Positioning of protection foil on OVC3000 boards in microwave appliances

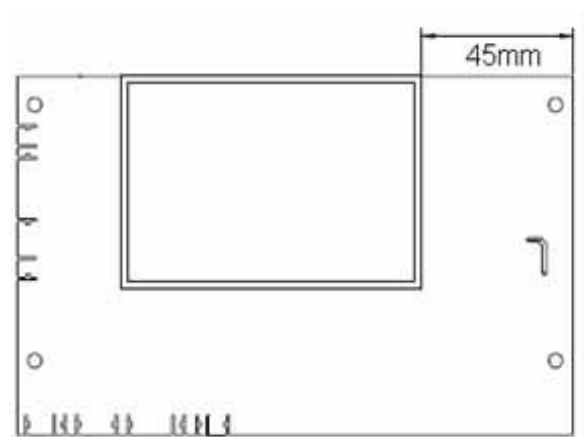
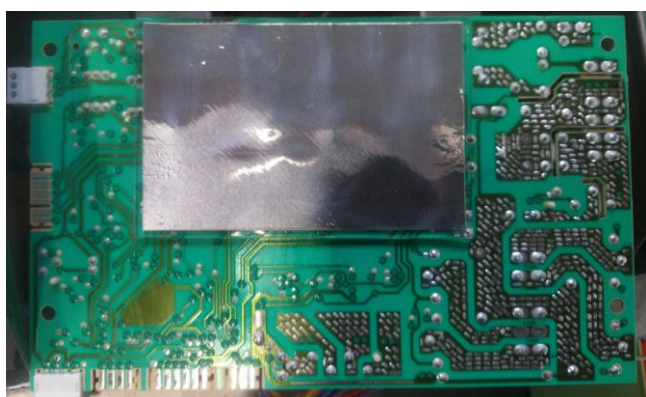
Residual microwave radiation may cause malfunction of OVC3000 power boards.

Foil should be placed on the bottom side of the board, 45mm from the edge, as seen on pictures above

To prevent this, factories have implemented additional protection foil to insulate vital components on the power board. The foil is available as separate spare part 5550593023, and should be used in all cases of OVC3000 replacement in microwave appliances.
